**APPLICABILITY:** 2013-2014MY BRZ

**NUMBER:** 07-120-17R

**SUBJECT:** Ignition Coils and Engine Harness- Design Changes to Address DTCs P0351, P0352, P0353 and / or P0354

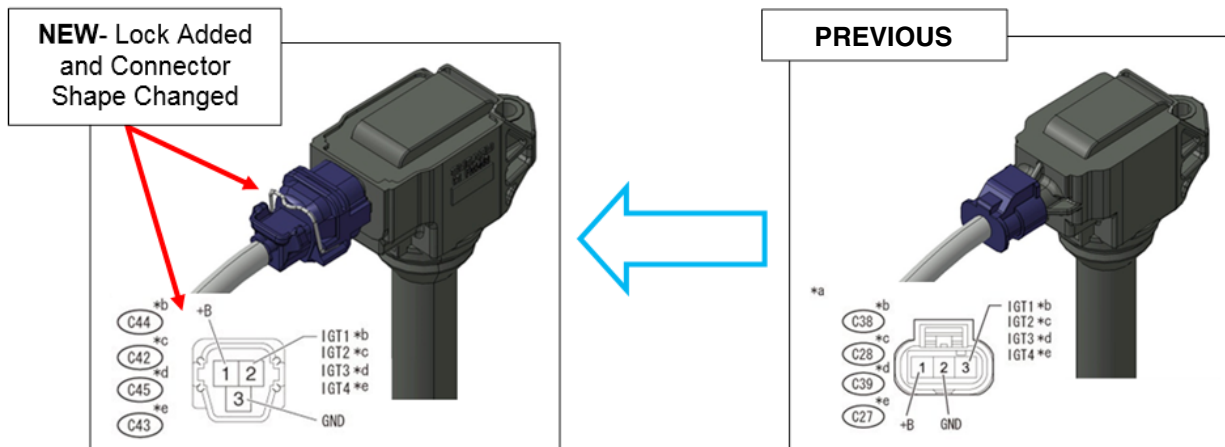
This Service Information Bulletin announces design changes made to the ignition coil and engine wiring harness in response to a limited number of cases related to the ignition coil primary / secondary DTCs listed above. The changes involve a shape change to the harness connector on the coil and to the corresponding engine harness connector. A positive lock mechanism has also been added to the engine harness ignition coil connectors to reduce the chances of becoming disconnected and causing a driveability concern and / or DTC(s).

The procedure for replacing the ignition coil(s) and engine harness is unchanged from the Service Manual. **NOTE:** There is no interchange between the old and new parts. For example, the new part number engine harness and new part number ignition coils must be installed as a set.
